UNITED STATES PATENT AND TRADEMARK OFFICE

APPLICATION NO.	FILING DATE	FIRST NAMED INVENTOR	ATTORNEY DOCKET NO.	CONFIRMATION NO.
10/707,019	11/14/2003	Matthew Hunt	RS149	1018
23470	7590	09/15/2006	EXAMINER	
SRAM CORPORATION 1333 N. KINGSBURY, 4TH FLOOR CHICAGO, IL 60622			WINDLEY III, WILLIAM R	
			ART UNIT	PAPER NUMBER
			3682

DETAILED ACTION

**FIG. 4**

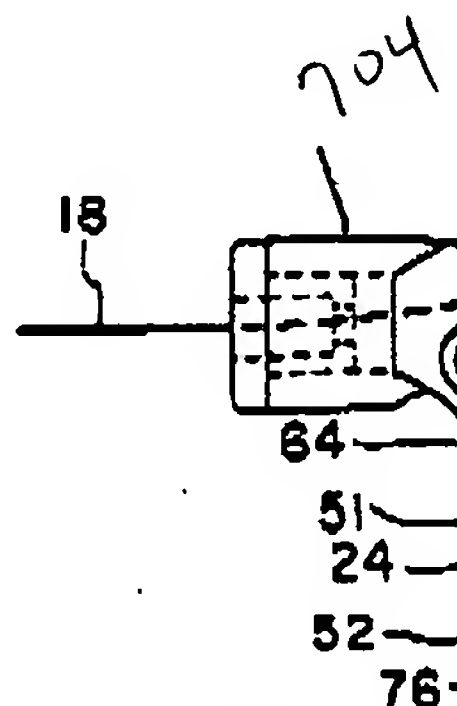
Re claims 1-6, 11-22, and 26 Yamano discloses a(n):

- Body (30)
- Handlebar (14)
- Actuator assembly (12)
- Lever arm (23)
- Pivot axis (See phantom line through 50 and 51, Figure 3)
- Suspension adjust cable (18)
- Actuator control assembly (22)
- Locking assembly (72)
- Adjustment assembly (73)
- Locking guide surface (91)
- Locking region (interior of 91)
- Locking follower assembly (121 and 35 are a subassembly of 27)
- Follower pin (121)
- Follower actuator and push-button (35)
- Biasing member (95)
- Adjustment guide surface (See surface of 61 Figure 3)
- Adjustment screw (34) having a threadform (49)
- Adjustment follower (51) having a threadform (interior of 51)
- Adjustment wheel (head of 34)
- Cable securing assembly (704, See Figure 4, marked by examiner)
- Actuation tab (63)
